Staff Presentation to the
Portland Design Commission

Design Review Hearing
LU 15-116838 DZM

818 SE 6th Avenue

May 7, 2015

ALTERNATING
HEIGHTS >6"

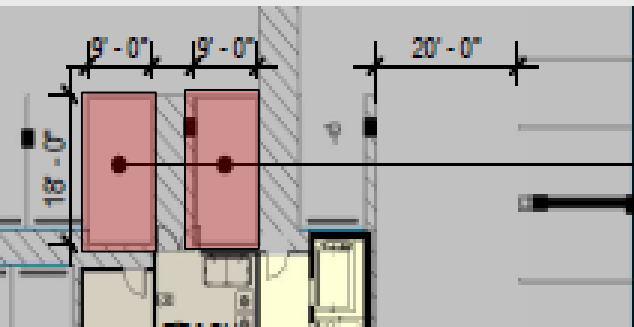
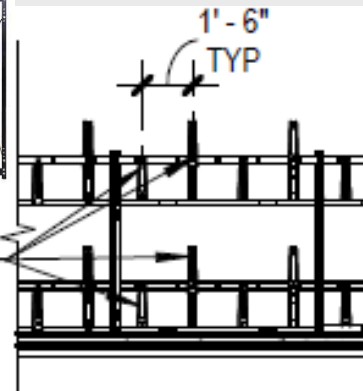
(2) LOADING SPACES

Reductions to:

- Vehicle parking space width from 8'-6" to 7'-10" – *Staff supportive*
- Bike parking space width from 2' to 18" – *Staff supportive*
- Height of loading space from 10' to 9' – *Staff supportive*

Active Ground Floor – DAR concern

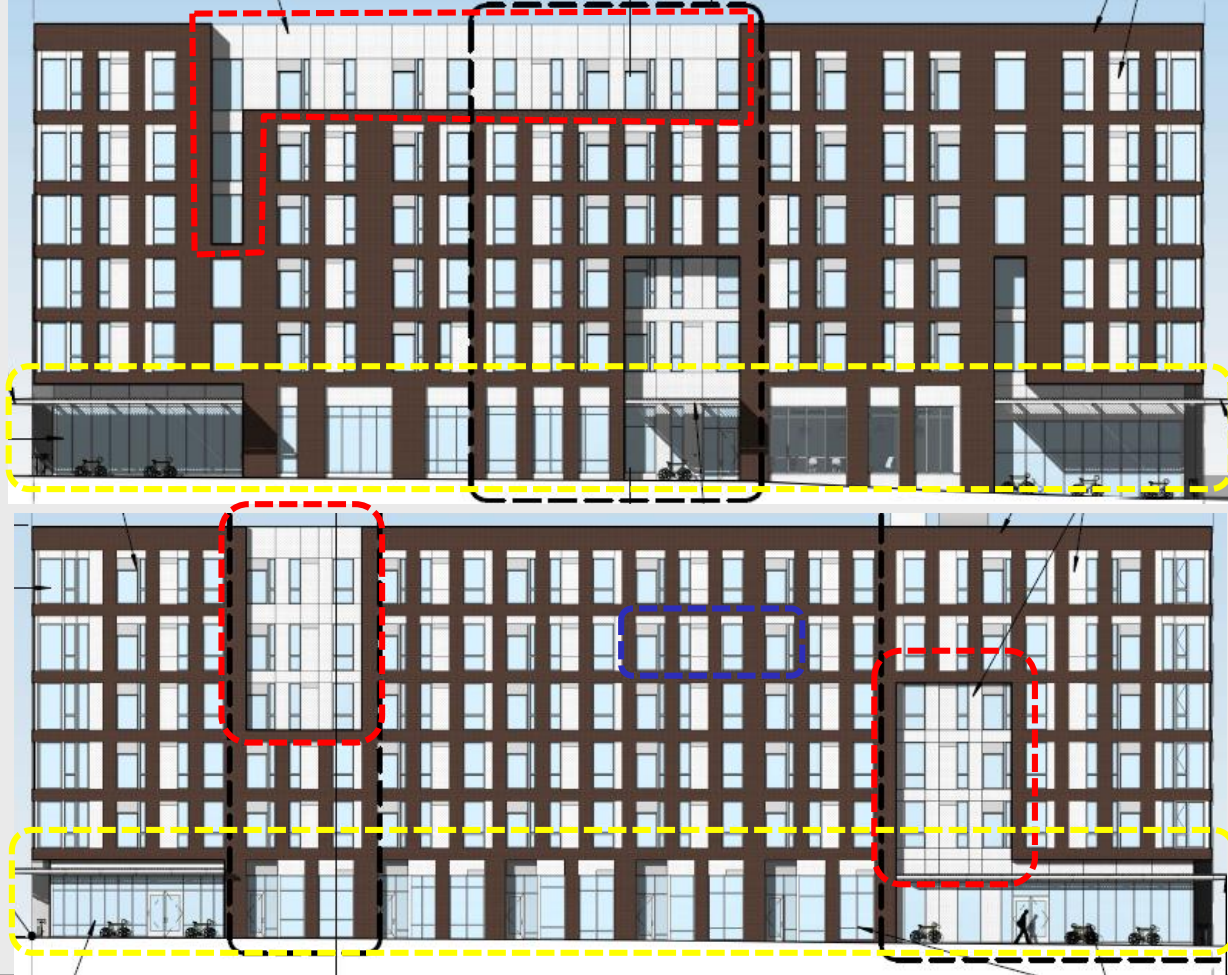
- Retail & office need, focus along Morrison, Belmont & 7th
- Residential amenities shift to quieter 6th
- “Drawn blinds” when residential units occur at ground floor.

Replace ground floor residential unit with active use

Replace live-work with retail/office or design to accommodate residential component at rear (loft) for active/retail at street-edge.

Composition

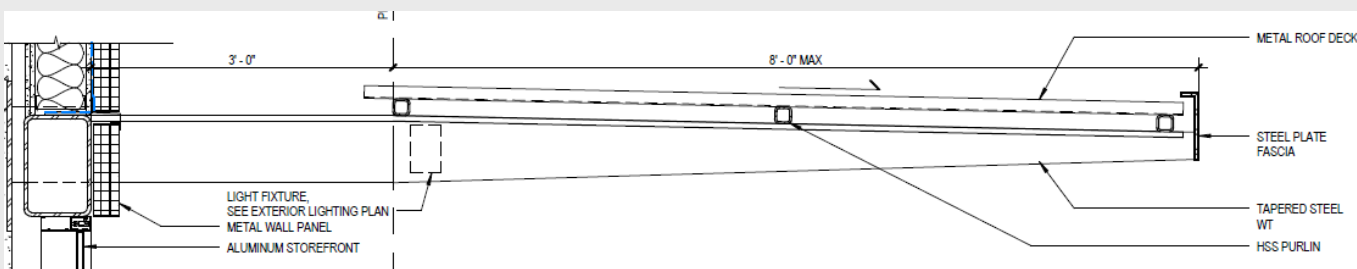
- Varied building's *base* – *unify, larger storefront patterning*
- Carved out masses – *more logical*
- Scale & monotony of courtyard elevations – *extend more brick into courtyard, group windows*
- Louvers – *more integrated & details needed*
- Canopies – *lighter design/material given 8' depth, add to courtyard residential entries*
- Balconies & façade treatments respond to the different frontages

Composition

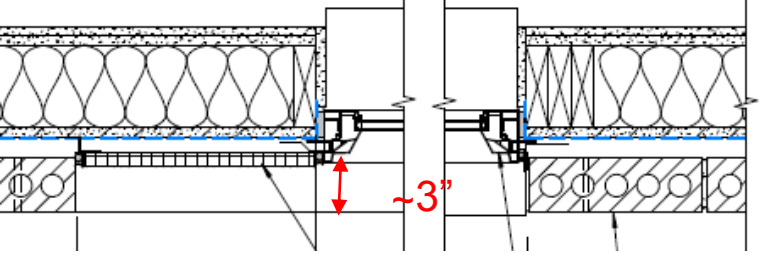
- Varied building's base – unify, larger storefront patterning at live-work
- Carved out masses – more logical
- Scale & monotony of courtyard elevations – extend more brick into courtyard, group windows
- Louvers – more integrated & details needed
- Canopies – lighter design/material given 8' depth, add to courtyard residential entries
- Balconies & façade treatments respond to the different frontages

Compatibility – early 20th century buildings in area:

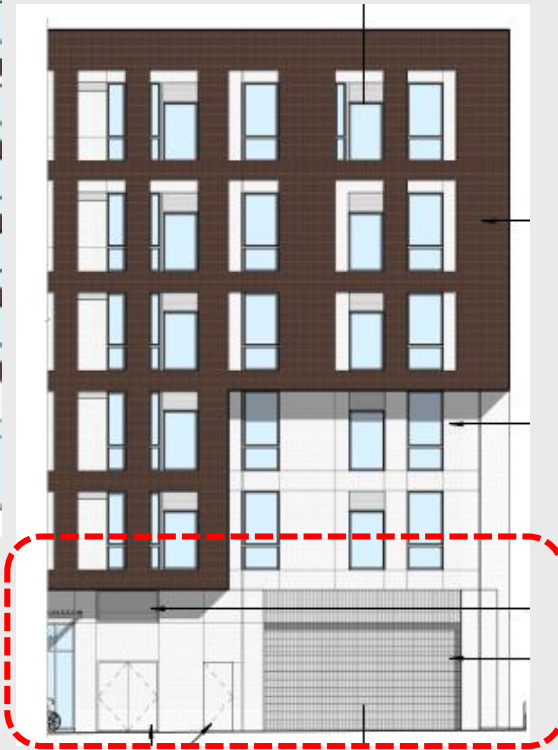
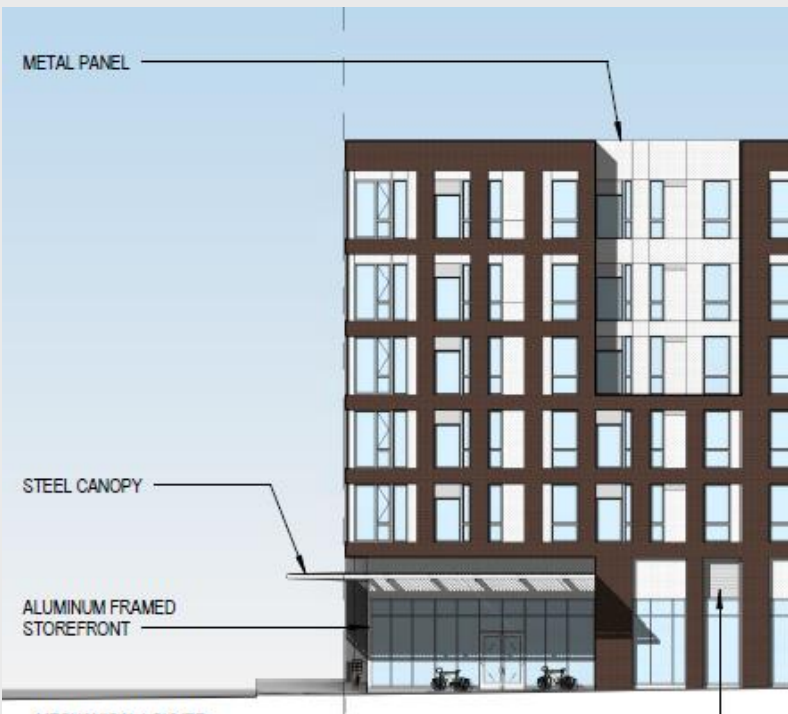
- Carved out masses – more logical, express 1/4 or 1/8 block development patterns, brick wrap returns (less applied)
- Use of white, flat metal panel – other profile or color?
- Shallow window depths (3'') – 7'' more typical

Materials:

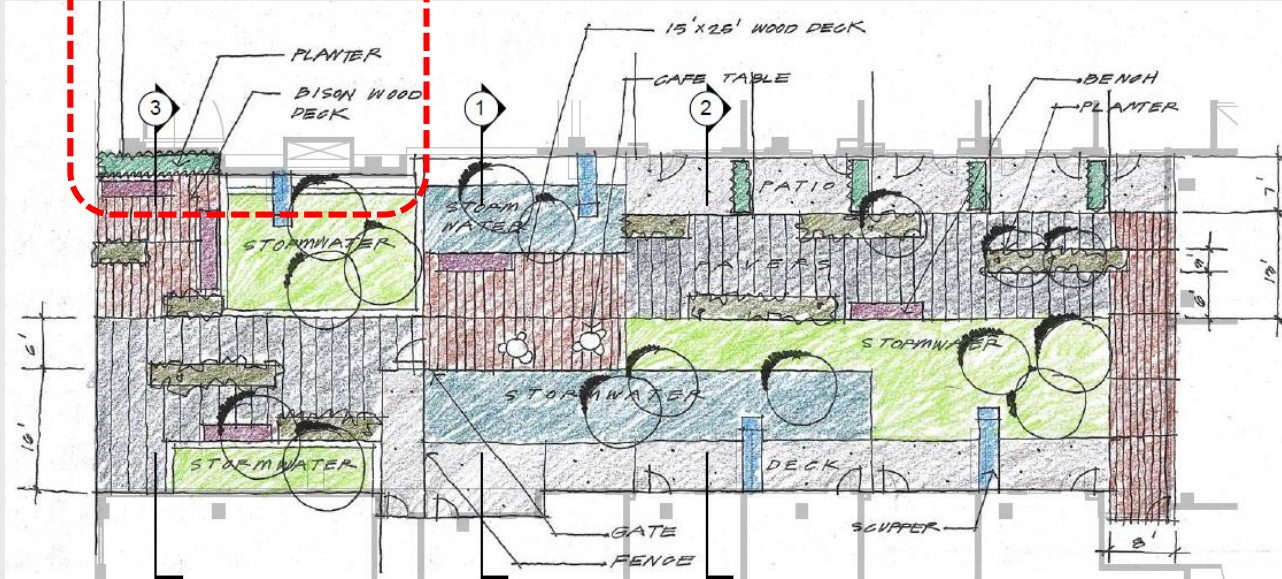
- White color & flat profile of metal panel
- Durability of metal panel at garage entry ground level
- Weathering steel planters in courtyard – in touch zone

Amount of usable space – DAR concern

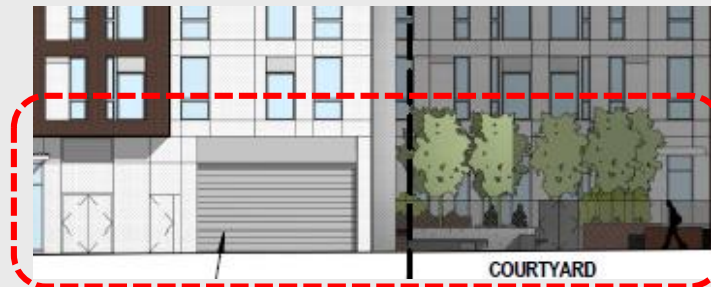
- 42' width is tight w/amt of stormwater planters
- Widen, reduce/remove non-stormwater planters, etc

Garage Entry Adjacency

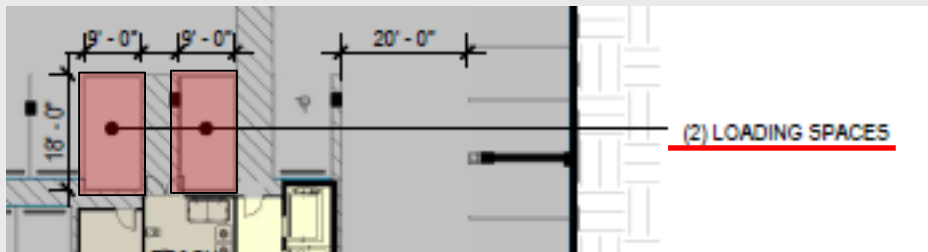
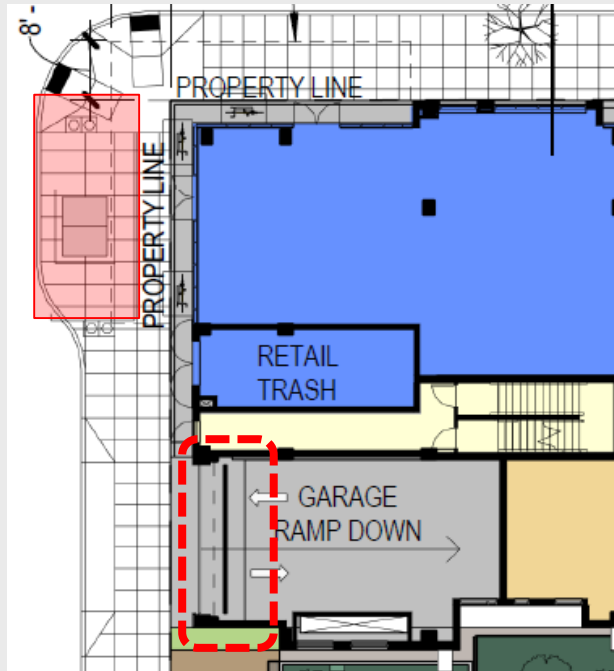
- Improve design of west and south wall of garage
- Bigger move – re-orient courtyard away from garage entry
